Bitters Pump Station Upgrades and Tank Replacement
Solicitation Number: CO-00601-SM
Job No.: 20-6007

ADDENDUM No.3
June 30, 2023

E-106

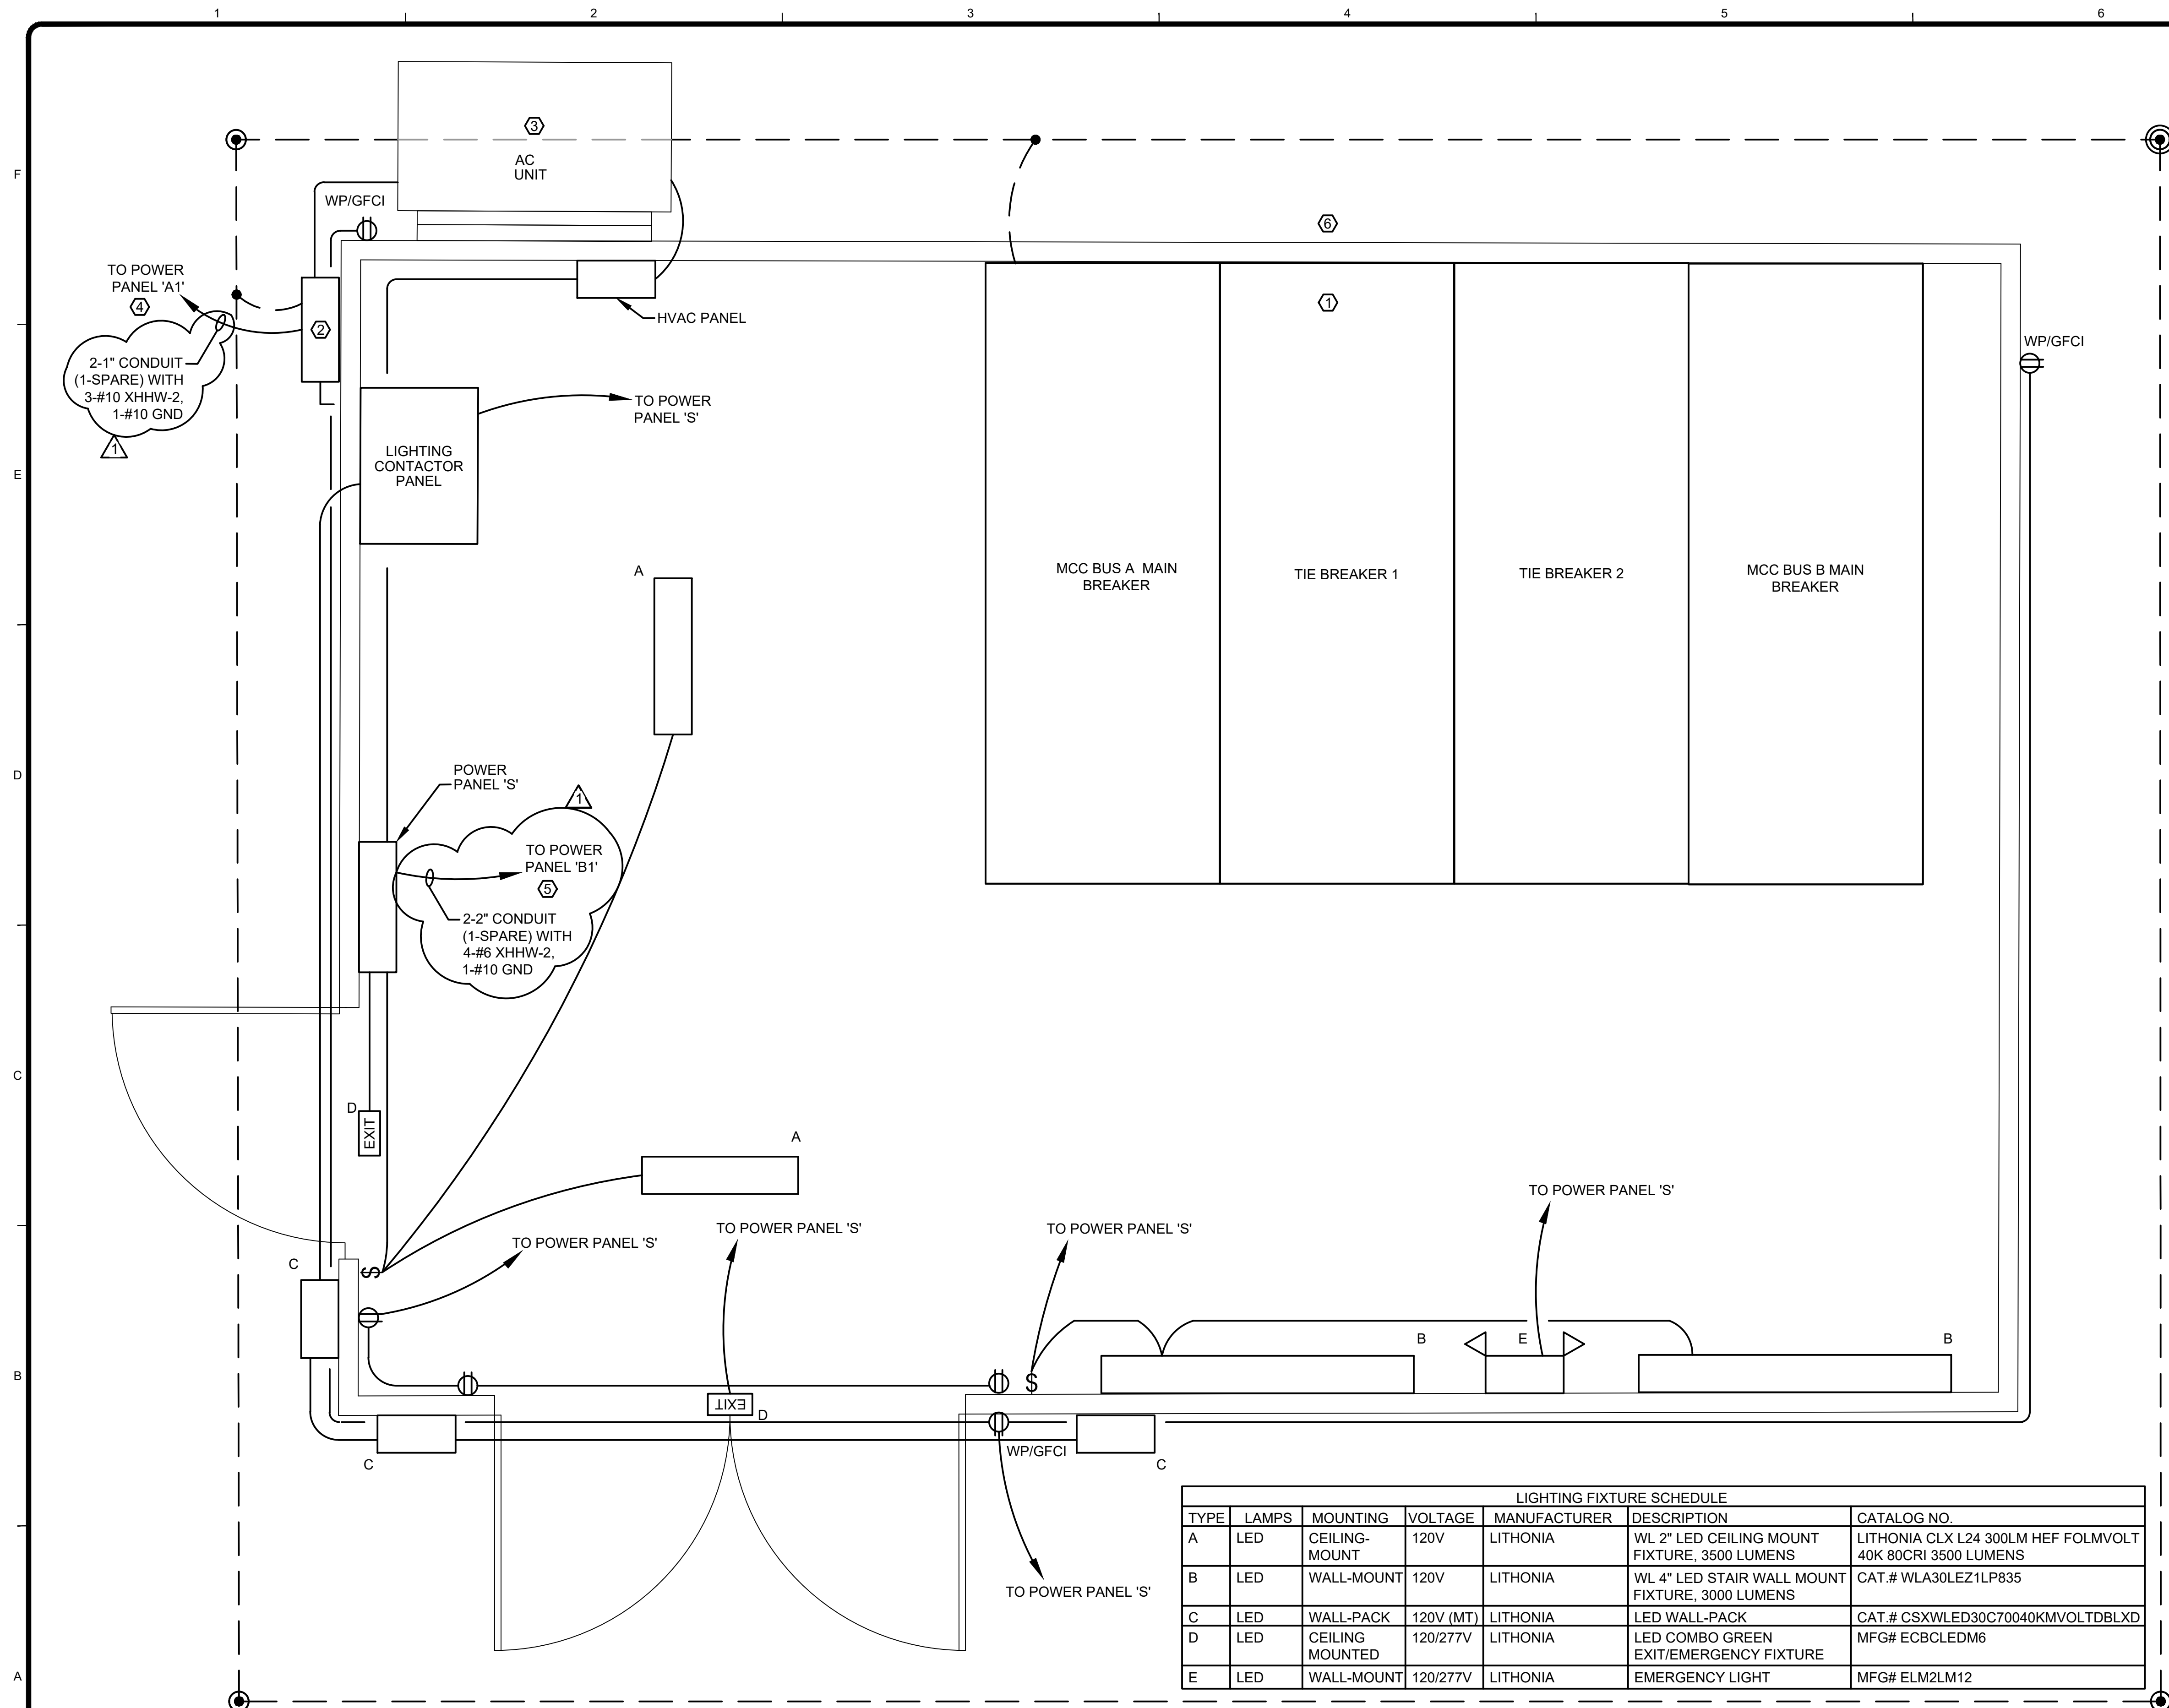
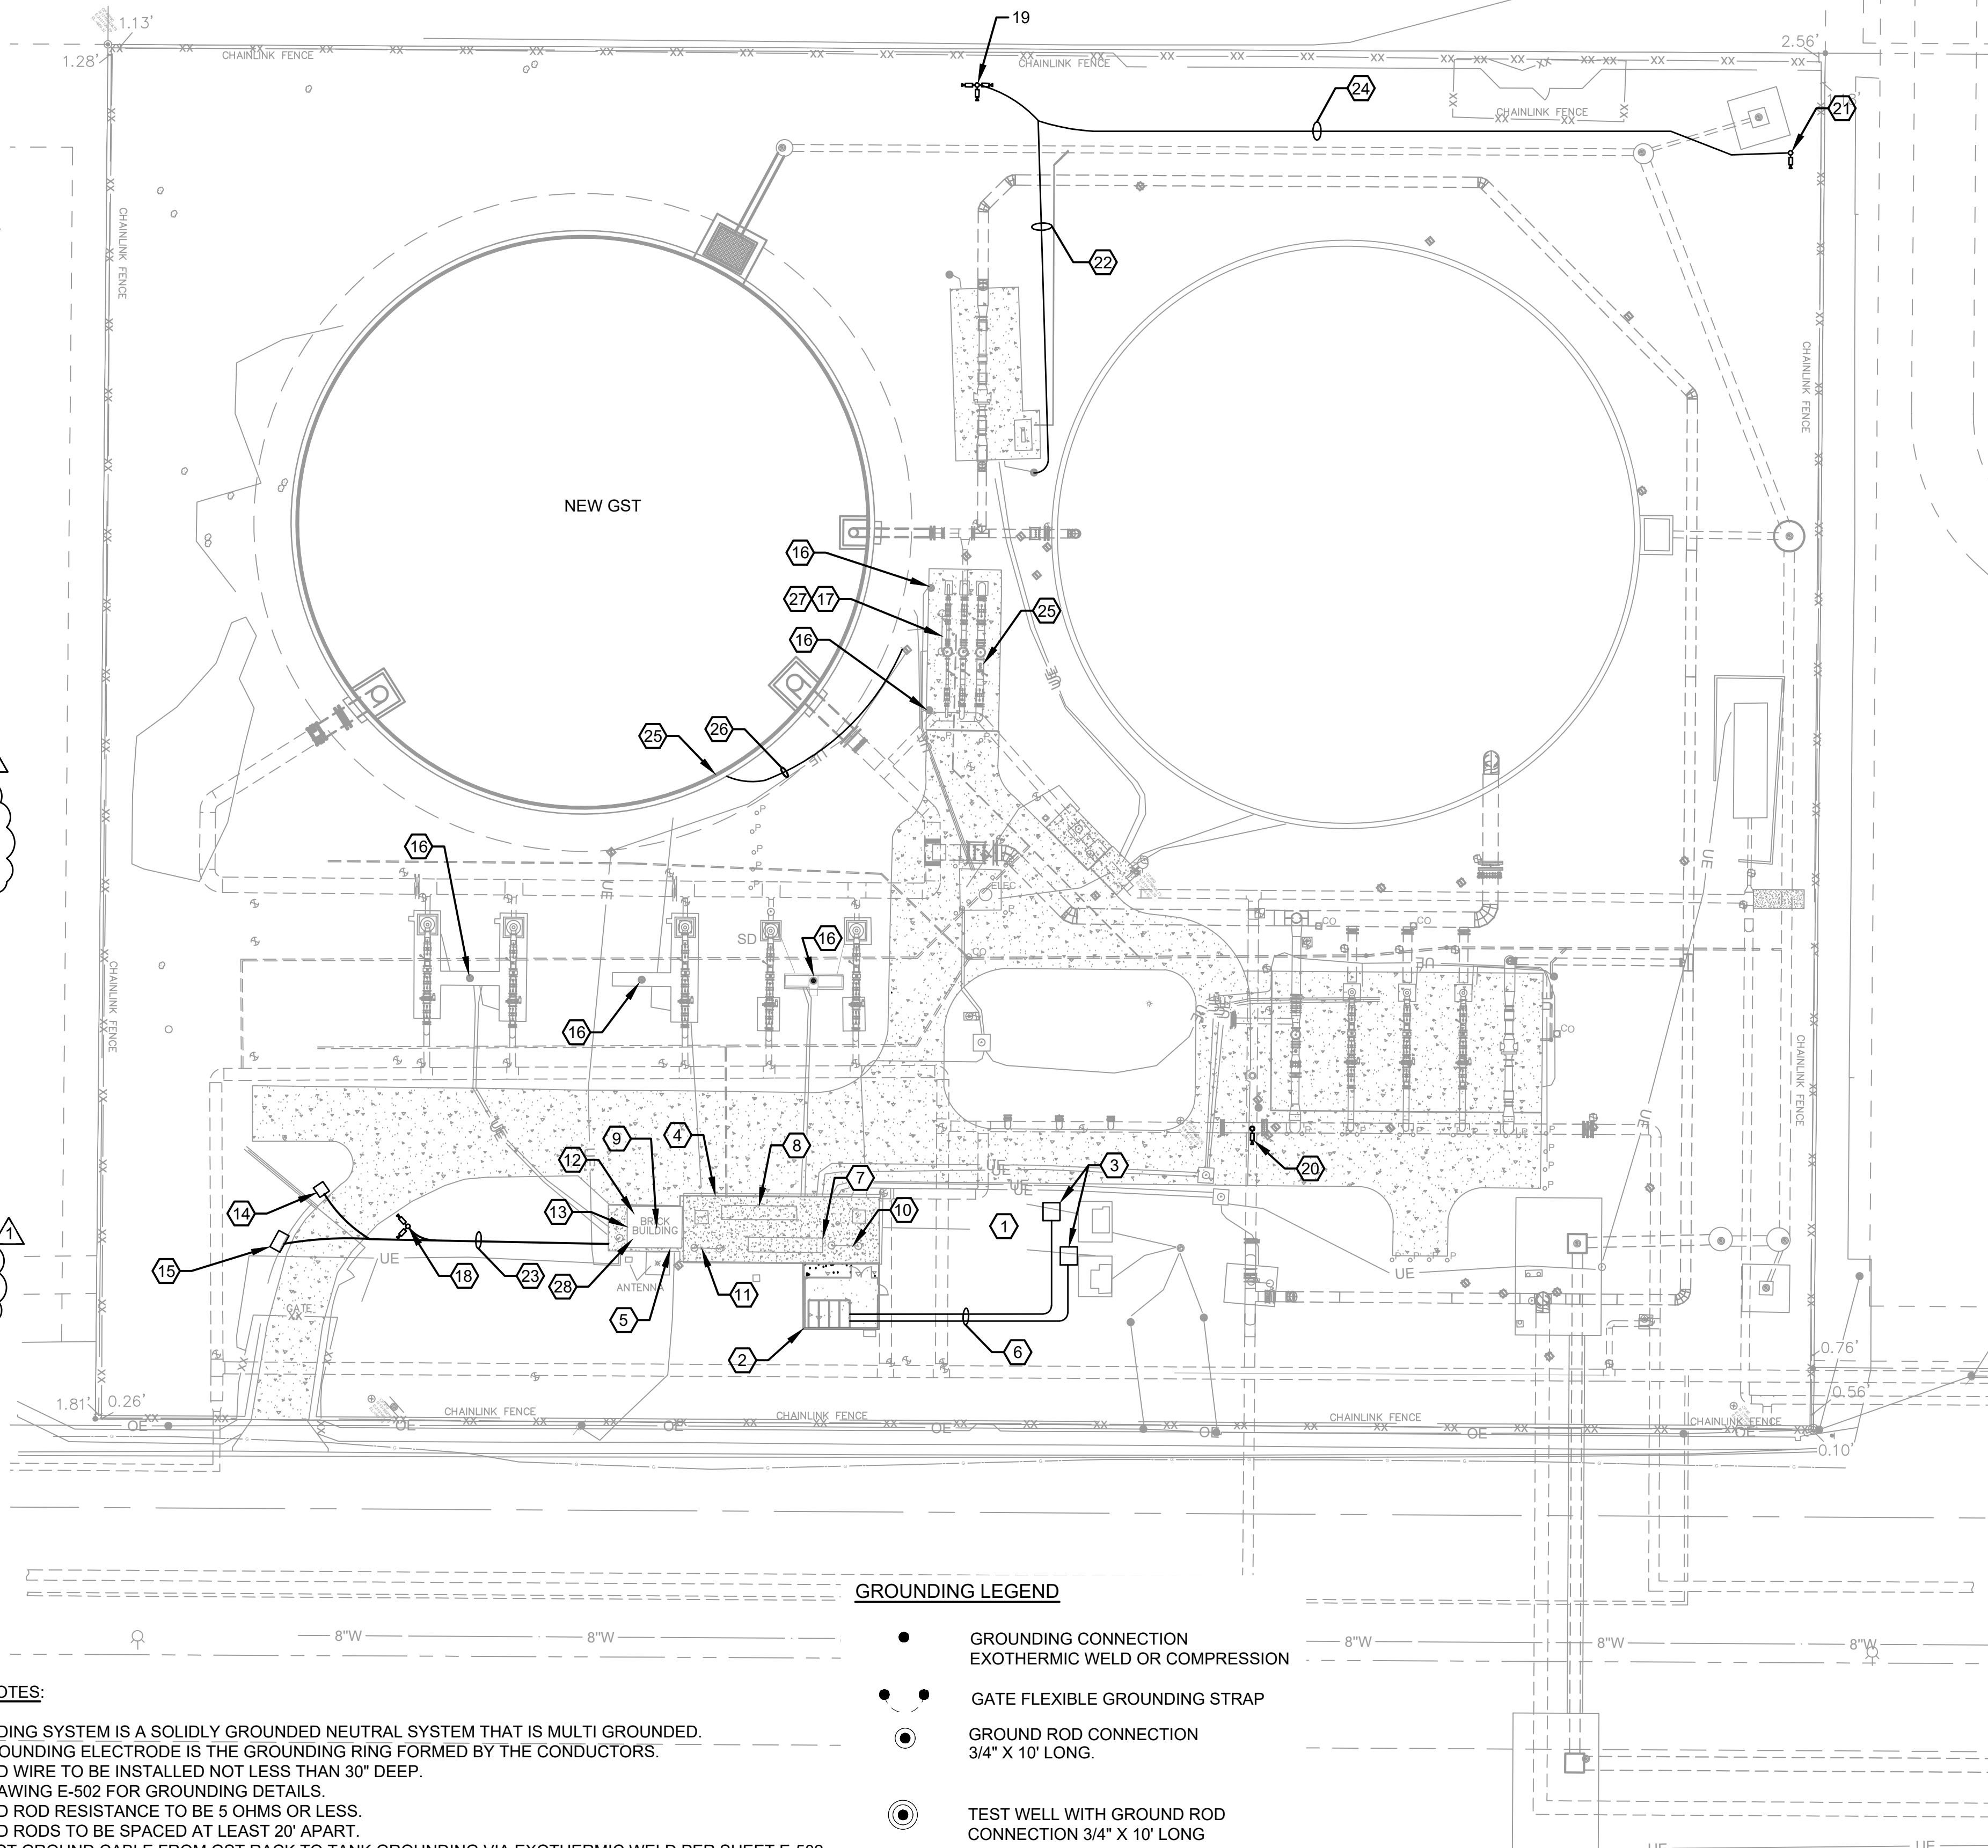
- 1. Question: Sheet E-106 Note 16 calls out a Hubbell fixture to be used to replace the existing demolished pole lights. Sheet E-114 Detail A calls out a different fixture and pole. Which part number is to be used for the area pole light replacements?**

Response: The model numbers for the light pole and fixture are Hubbell RTS-K-20-60-A-TA-K2-DBS-VM2 and Hubbell UR20-28L-70-4K8-5W-UNV-PT23-DBS-7PR-SC, respectively. See “Changes to the Plans” Sheet E-114.
- 2. Question: Please provide Word Version of the Evaluation Criteria fillable forms.**

- 15 NEW SLIDE GATE ACCESS PANEL. REFER TO SHEET I-102.
- 16 LIGHT POLE AND FIXTURE TO BE REPLACED WITH HUBBELL RTS-K-20-60-A-TA-K2-DBS-VM2 AND HUBBELL UR20-28L-70-4K8-5W-UNV-PT23-DBS-7PR-SC.
